ATTACHMENT 0002, sow, 3/1/2004
Statement of Work

1.0 **Scope.** This Statement of Work (SOW) defines the efforts required to produce the products required by this solicitation IAW the Documents listed below. The items being purchased are entitled " Five Spare Parts for AN/VVS-2 ".

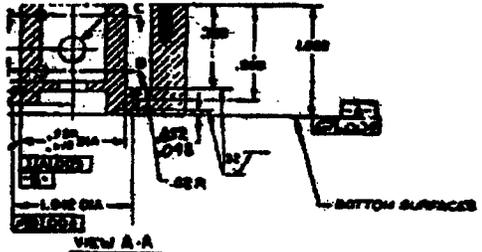
IN ZONE B-6, C-5, AND C-4 CHANGE DIMENSIONS TO REFLECT CORRECT TOLERANCE FOR COMPATIBILITY WITH LENS DIMENSIONS. SEE NOR 010 FOR SPECIFIC DIMENSIONS.

DIMENSIONS ON DRAWING PERMIT AN INTERFERENCE CONDITION BETWEEN GLASS AND BARREL. THE TOLERANCE ON THE O.D. DIMENSION IS UNNECESSARILY TIGHT FOR THE END ITEM USE.

1) CHANGE DIMENSIONS IN ZONE B-6, C-4, AND C-5 AS FOLLOWS:

E5GJ255-011

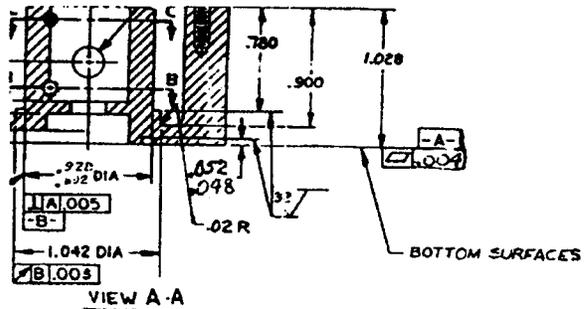
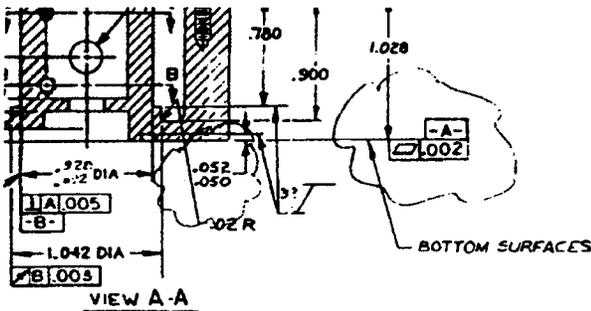
15. LOWEST ASSEMBLY AFFECTED NOMENCLATURE VIEWER /ASSEMBLY DRIVERS, AN/VVS-2(V)			PART NUMBER SM-D-771480/5005820		NPN 5855-01-235-5489	
16. DESCRIPTION OF CHANGE IN ZONE B-4.1, CHANGE DIMENSION .052 TO .052 AND FLATNESS REQUIREMENT FROM .002 TO .004

17. NEED FOR CHANGE TO BRING THE FLATNESS AND DIMENSIONAL TOLERANCES IN LINE WITH THE CASTING CAPABILITY TO HOLD TOLERANCES.						
18. PRODUCTION EFFECTIVITY BY SERIAL NUMBER N/A			19. EFFECT ON PRODUCTION DELIVERY SCHEDULE NONE

1) IN ZONE B-4,5, CHANGE DIMENSION AND FLATNESS REQUIREMENTS AS SHOWN BELOW:
